STATE OF DELAWARE
DEPARTMENT OF TRANSPORTATION
800 BAY ROAD
P.O. BOX 778
DOVER, DELAWARE 19903

February 17, 2009

DeIDOT Contract Number: 95-090-01; Federal Aid Project Number: IM-N056(27)
I-95 Delaware Turnpike Improvements Project
I-95/SR 1 Interchange/I-95 Turnpike Mainline
Turnpike Mainline from SR 1 to SR 141; I-95/SR 1 Interchange; I-95 Northbound
Widening Extension
New Castle County, Delaware
Environmental Reevaluation [*Change in interchange design*]

The current reevaluation details modifications in the design of the I-95/SR 1 interchange portion of the project. The design changes are being incorporated into the project to provide additional traffic operational and safety improvements within the interchange. An environmental evaluation of the currently proposed design has been completed, and the changes would increase the impacts to wetlands by an additional 0.26 acres. Mitigation for this additional impact will be accommodated within the Cathcart wetland mitigation site (identified as Site 7 in the

I-95 / SRI INTERCHANGE IMPROVEMENTS
 ENVIRONMENTAL REEVALUATION
FIGURE 3 (1 OF 5)
MODIFIED DESIGN

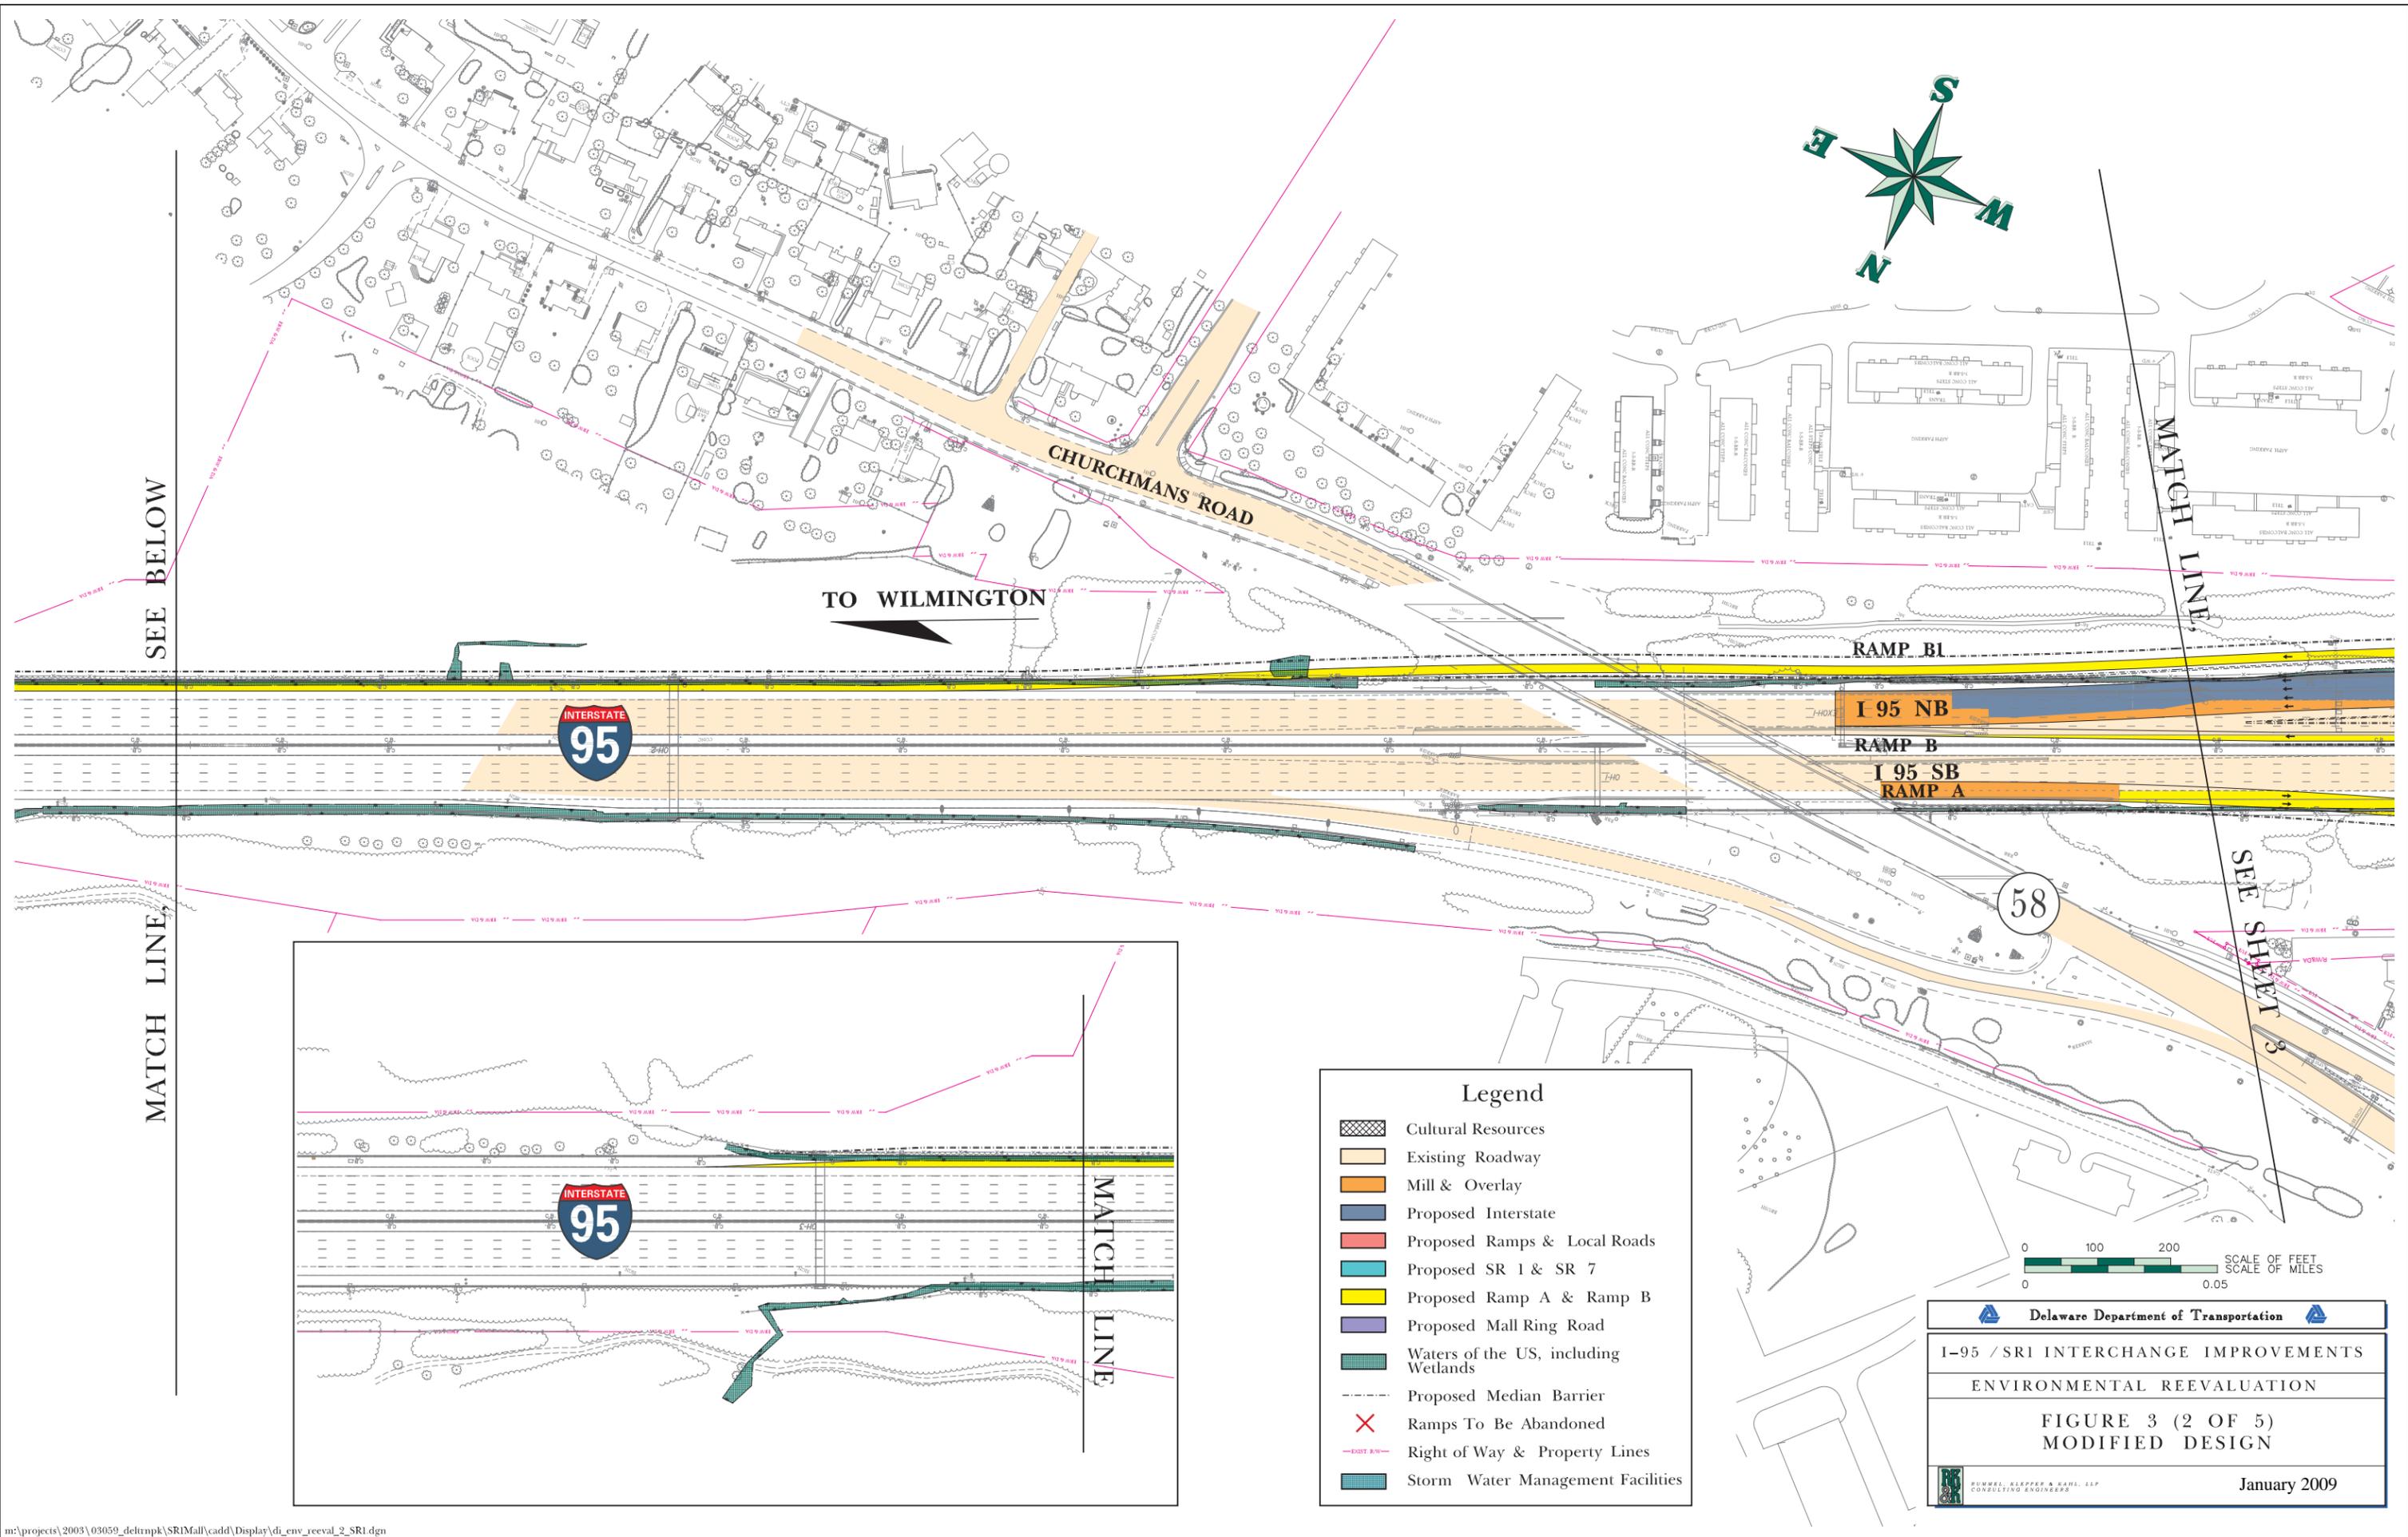
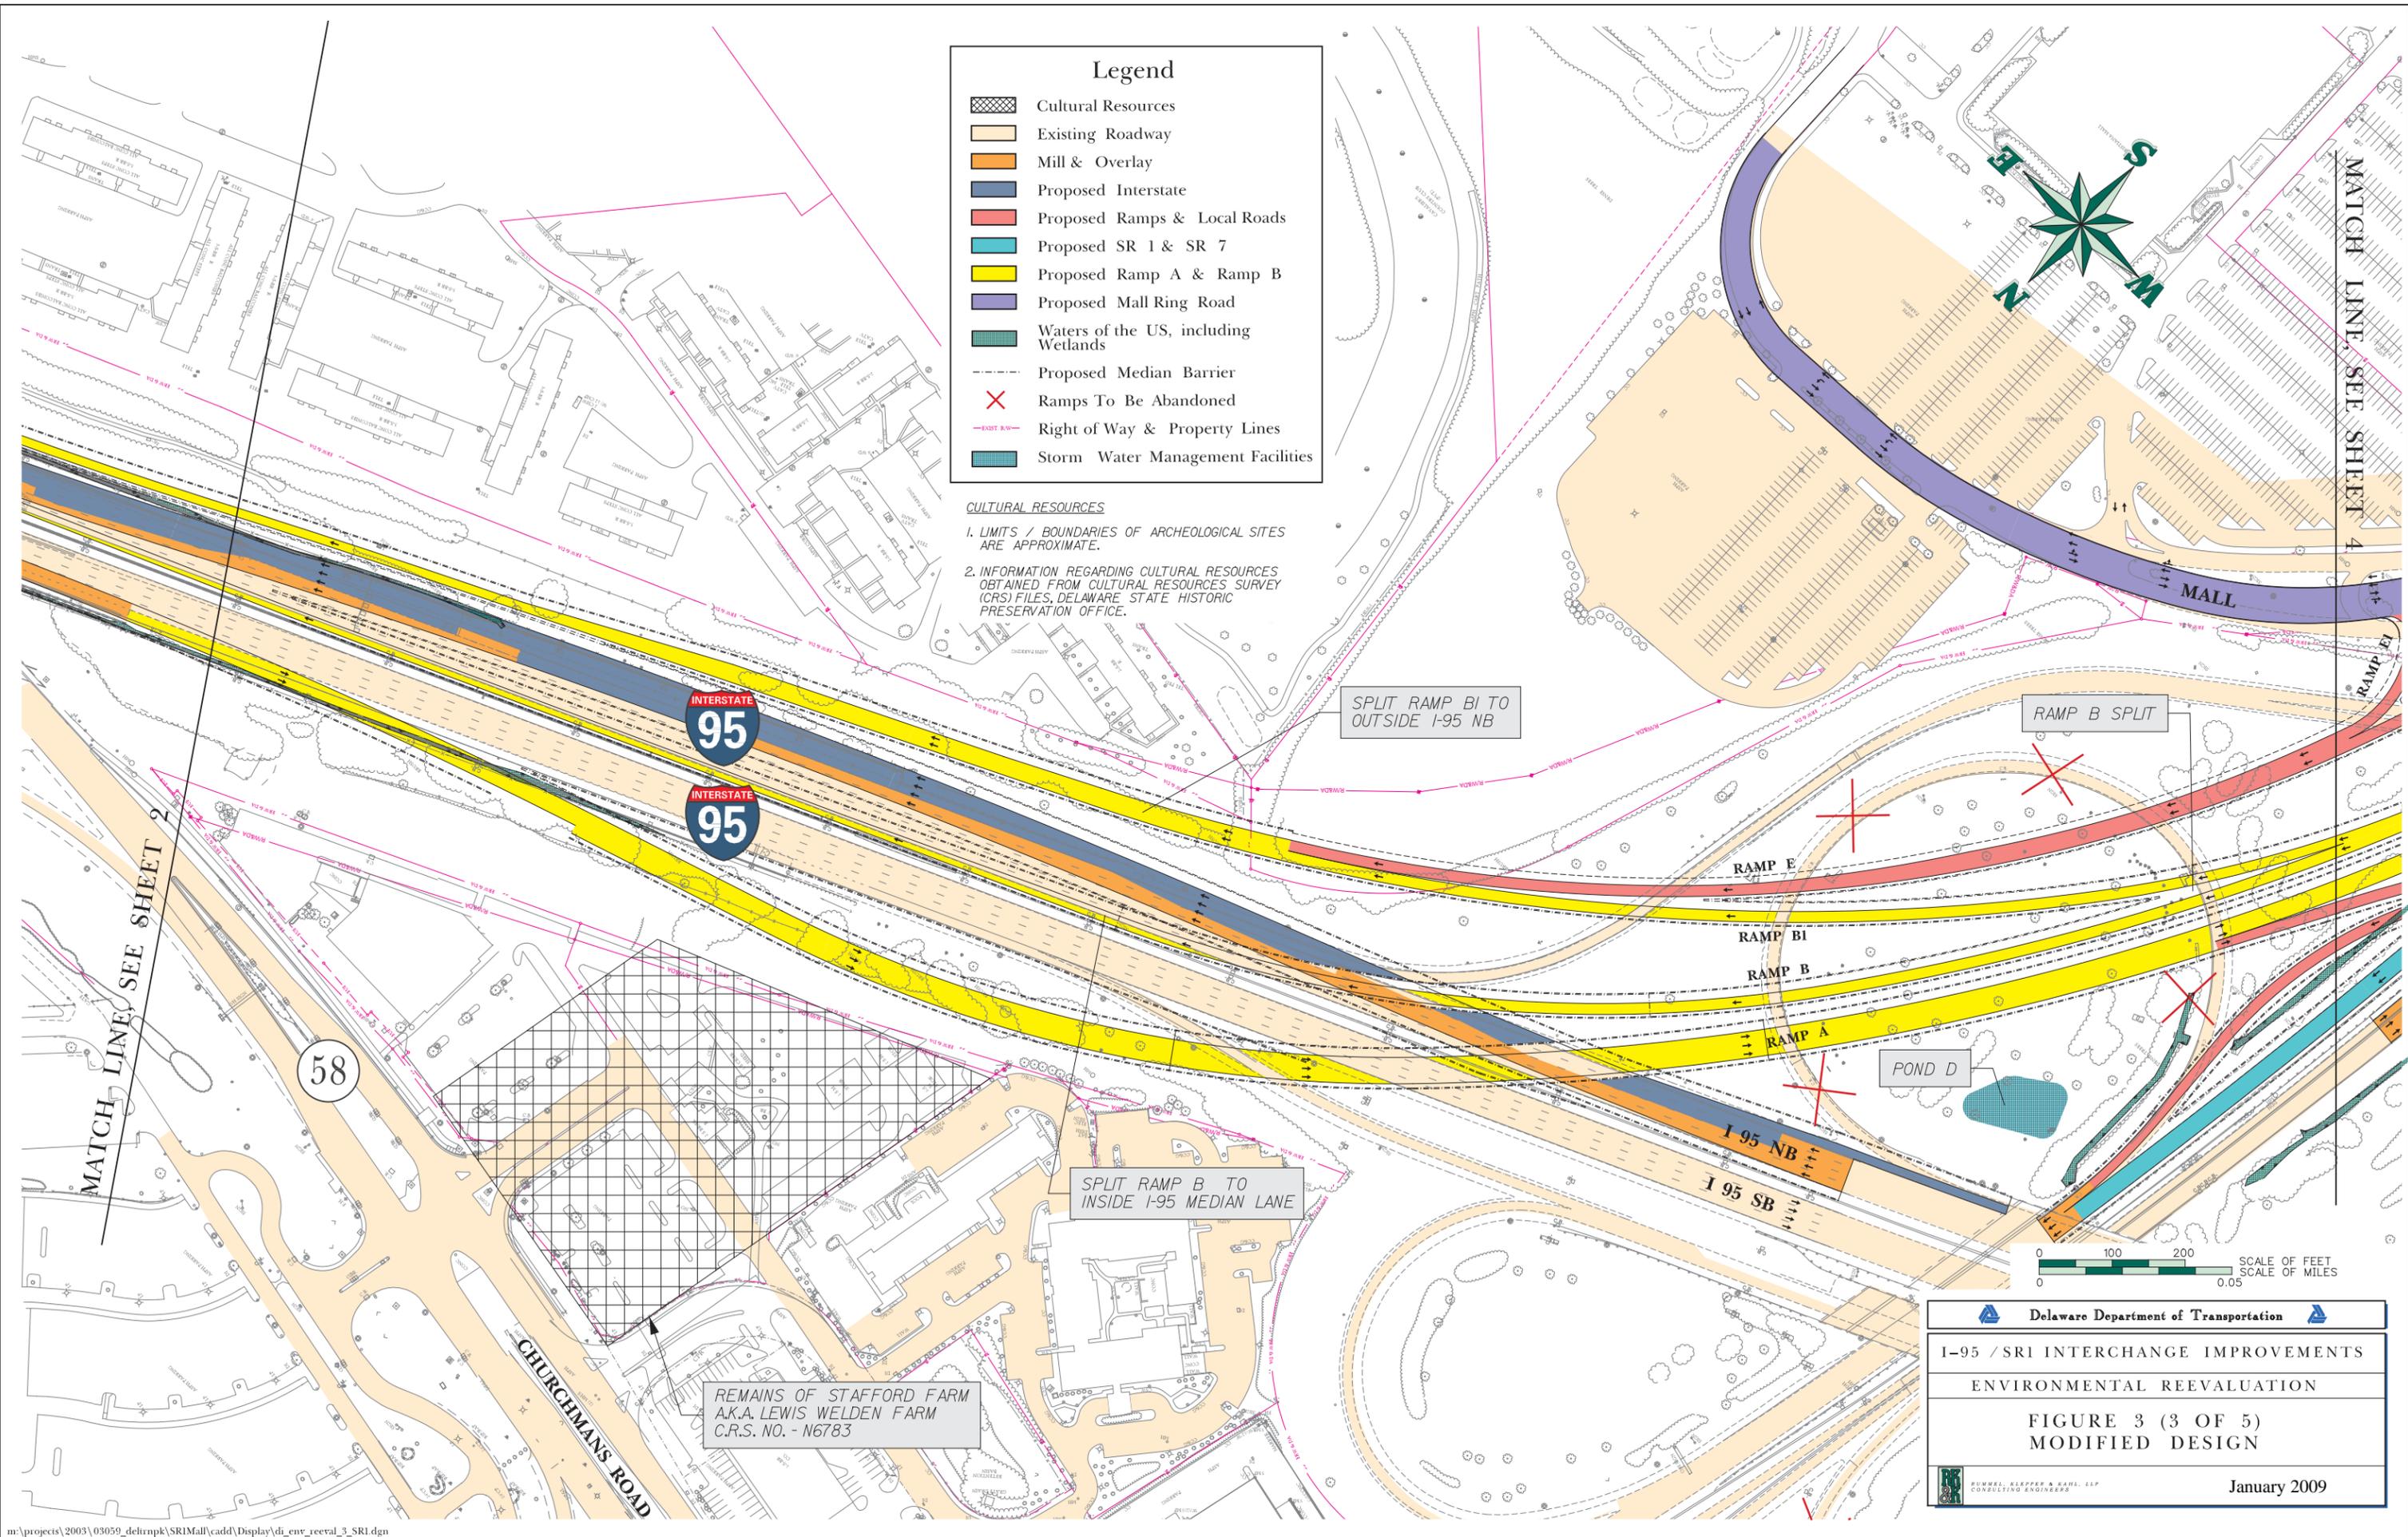
- The existing southeast quadrant loop ramp (from I-95 northbound to SR 7 northbound) has been eliminated and replaced by a semi-directional flyover ramp (identified on **Figure 3** as Ramp C) that extends from the southwest outer ramp from northbound I-95, passes over SR 7 and merges with northbound SR 7.

- The existing northbound lanes of I-95, north of the interchange, are shifted approximately 40 feet to the outside to accommodate Ramp B, which will fly over northbound I-95 and extend as the median lane of I-95.
- Ramp B (SR 1 northbound to I-95 northbound) will split in the vicinity of the southwest quadrant. The left lane will fly over northbound I-95, and become the median lane of the northbound I-95 mainline, as noted above. The right lane of Ramp B (Ramp B1) will extend along the outside of existing northbound I-95 and remain barrier-separated from the northbound I-95 mainline until north of the Churchmans Road bridge, where the lane merges with the existing outside mainline lane.
- The ramp (Ramp R1) to/from the Christiana Mall Road will be relocated approximately 150 feet south of its present location.

- The relocation of the Ramp R1 bridge approximately 150 feet to the south will allow for a lower profile for the ramp bridge and the reconstructed Christiana Mall Road, thus reducing the impact to the mall parking lot and eliminating a proposed retaining wall. Shoulder reductions in some areas have been reduced from 16/24 feet to 12 feet to accommodate the changes and avoid additional property acquisition from the Mall.
